Pleasant View Planning Commission

Meeting Agenda

Planning Commission Staff Report

Vista Lago – Pole Patch II #28 Single-Family Dwelling Conditional Use Permit and Site Plan

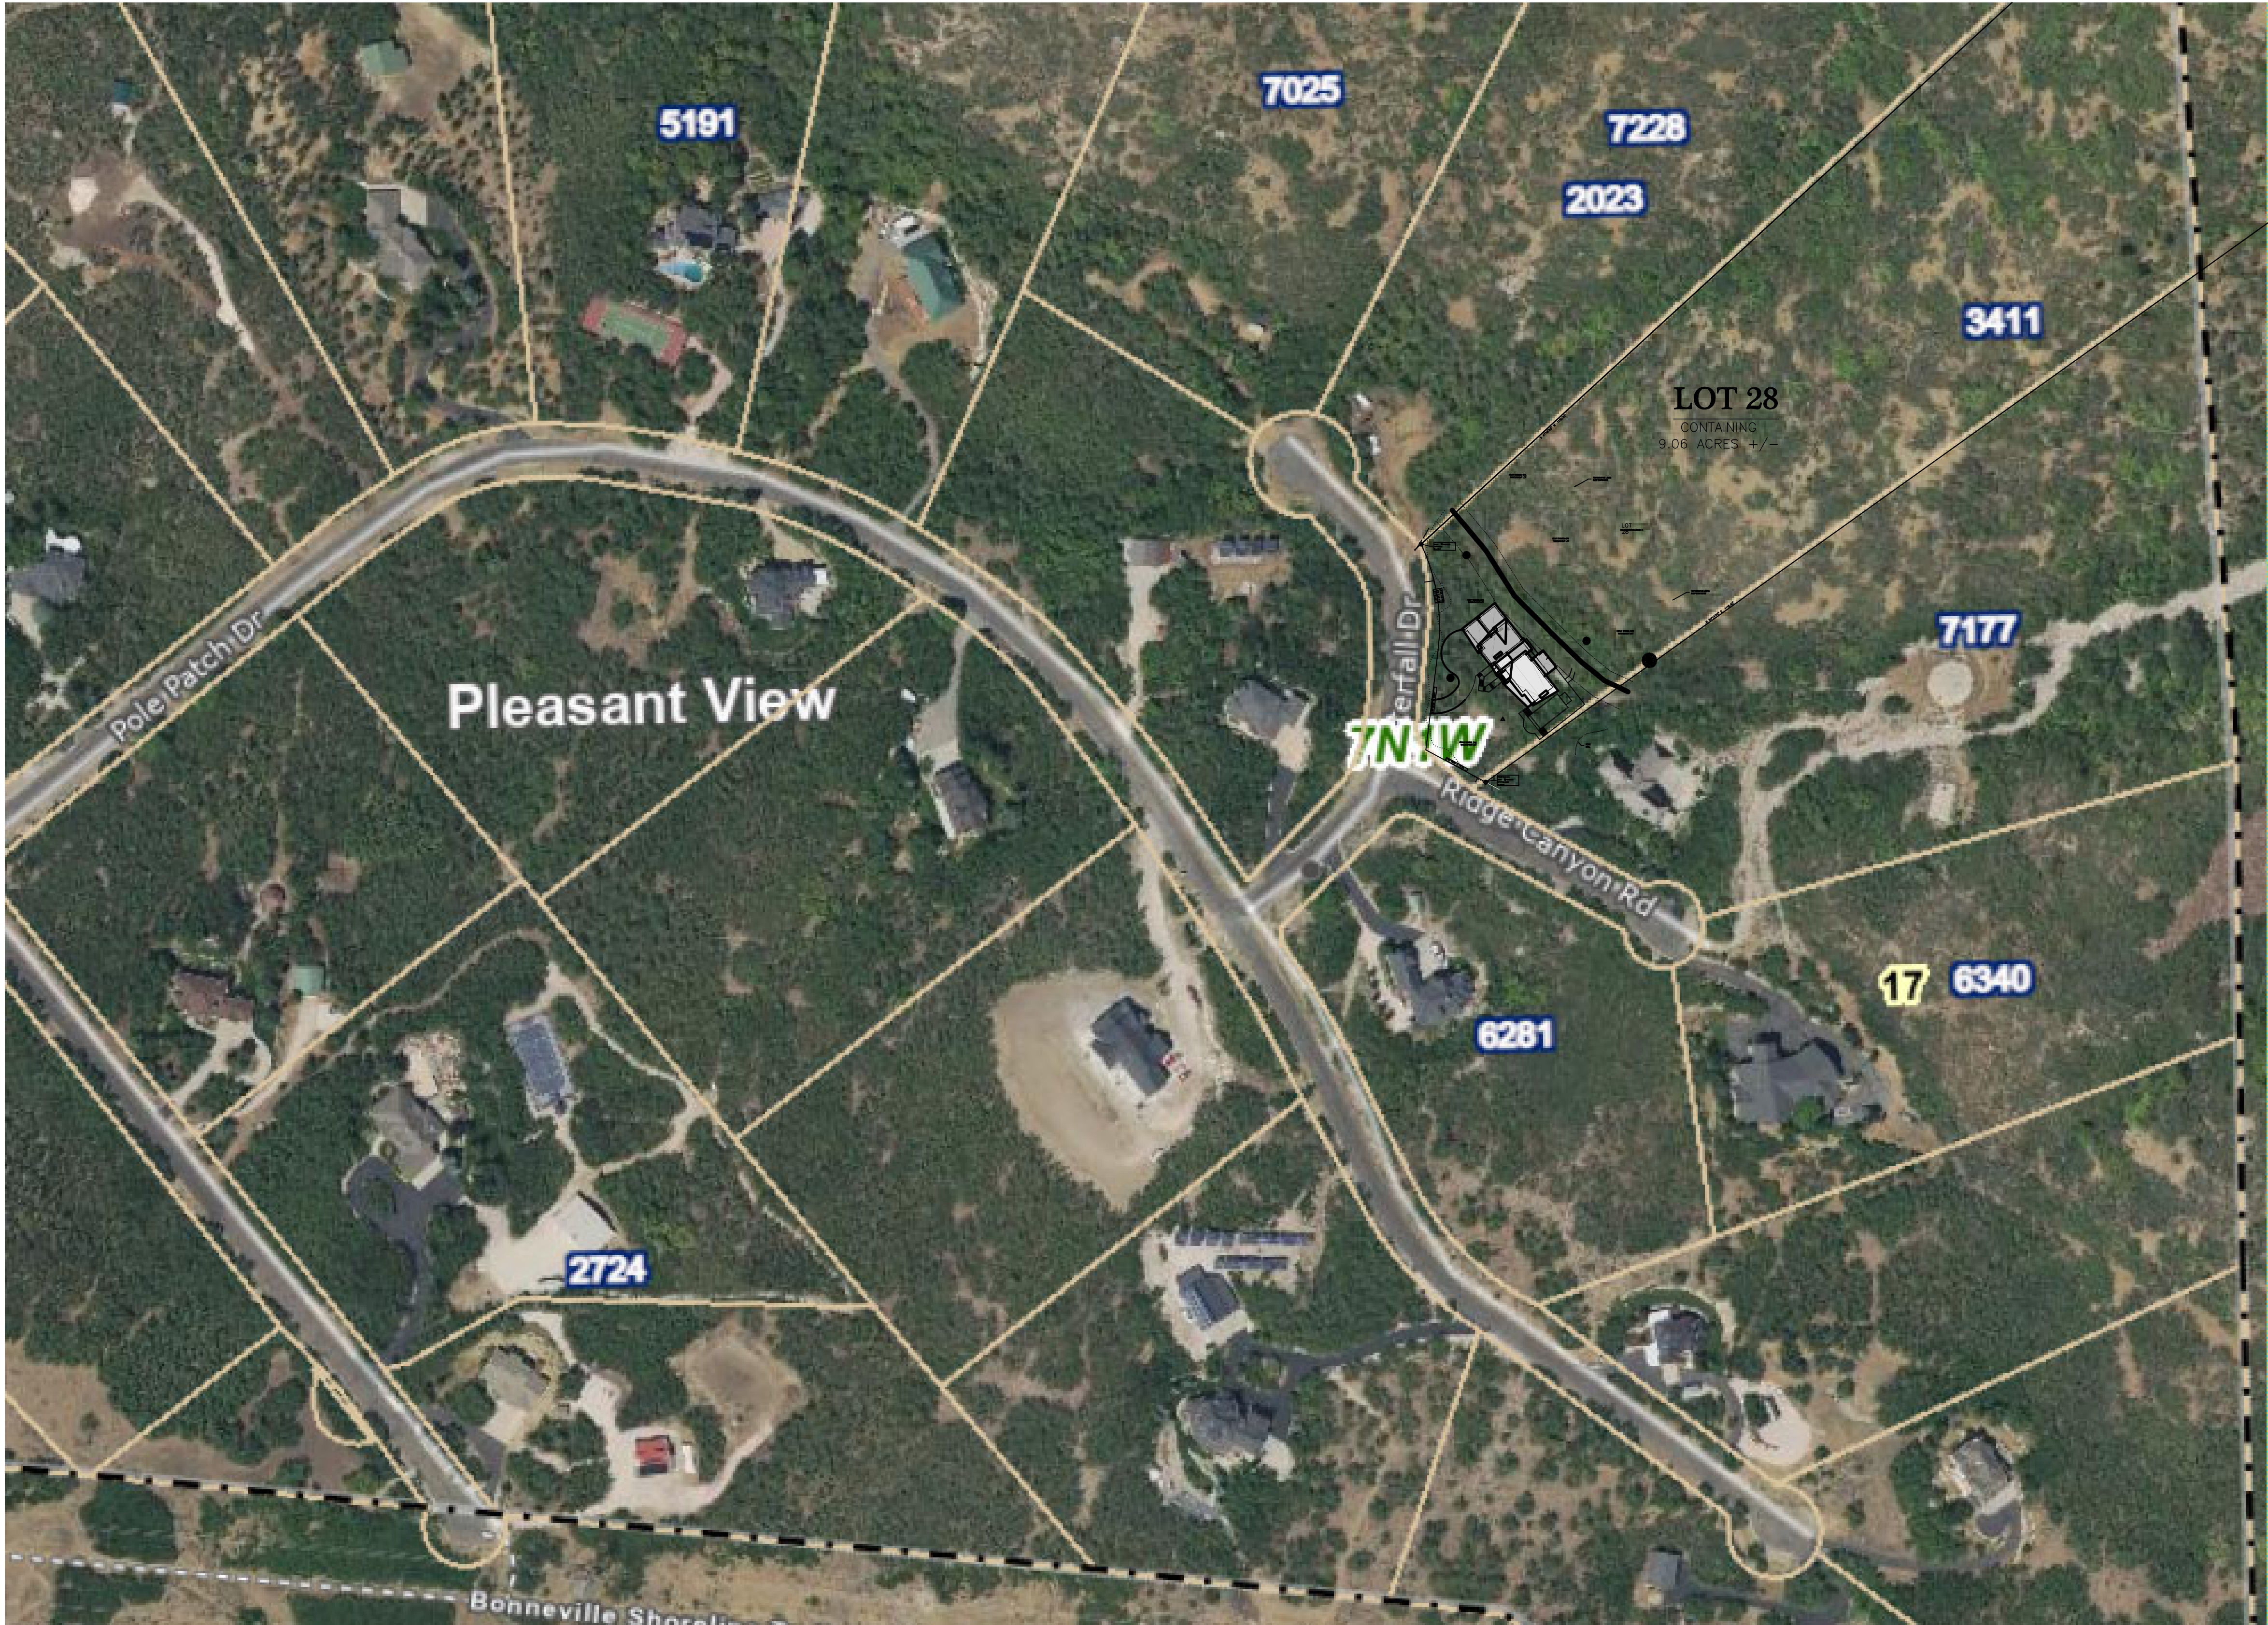
Staff Comment: A grading plan is required and has been provided by the applicant. The applicant has been requested to demonstrate that the grade of the soil in the final grading plan has an angle equal to or less than the angle of repose (See Sheet L-1.2 of Exhibit B).

- A grading plan is required and has been provided by the applicant. The applicant needs to demonstrate that the grade of the soil in the final grading plan has an angle equal to or less than the angle of repose.
